RESPONSE TO COMMENTS

Re: Waterstone Site Plan No 4, DA-1758-10, 4th submittal comments

Please accept this letter in response to your December 2024 review comments on the Waterstone Site Plan No 4, DA-1758-10, 4th submittal comments.

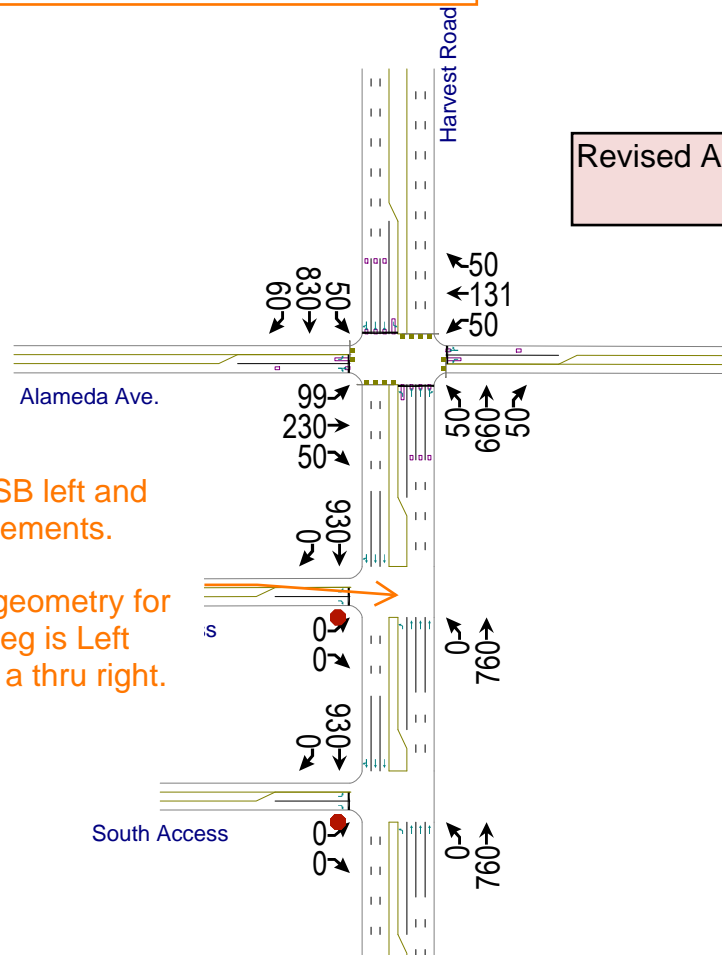
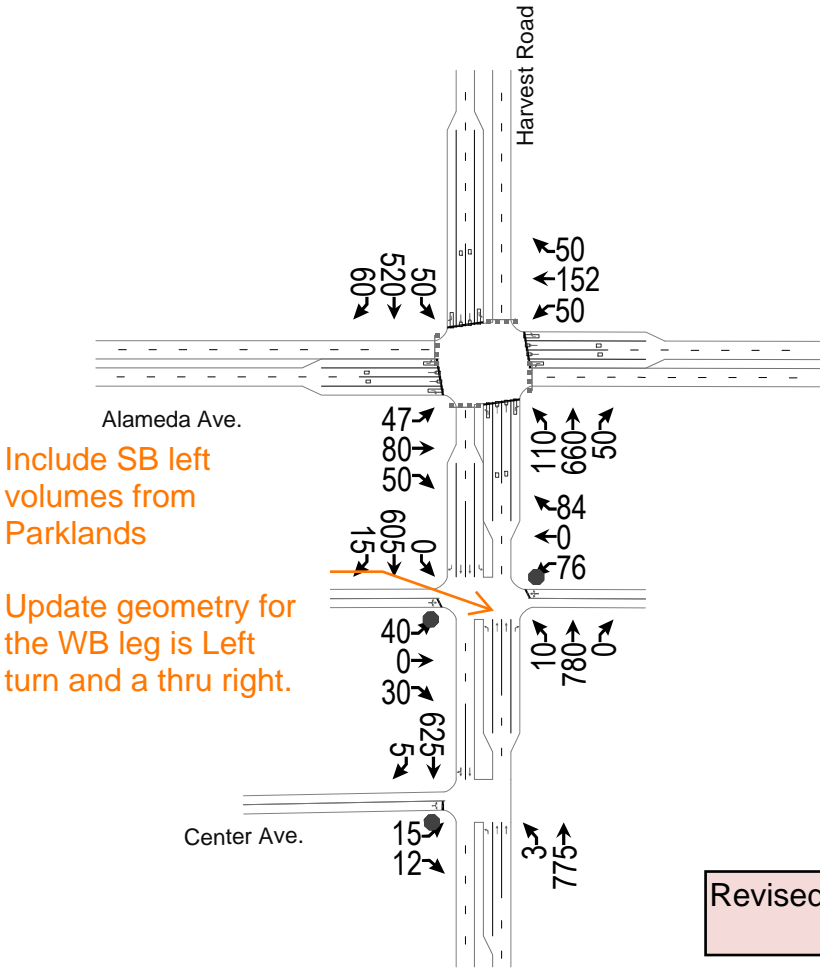
There are more background lanes on Harvest than during build condition. The background lanes should match or at least be less than the build lanes.

Include SB left and WB movements.

Update geometry for the WB leg is Left turn and a thru right.

Revised Accordingly
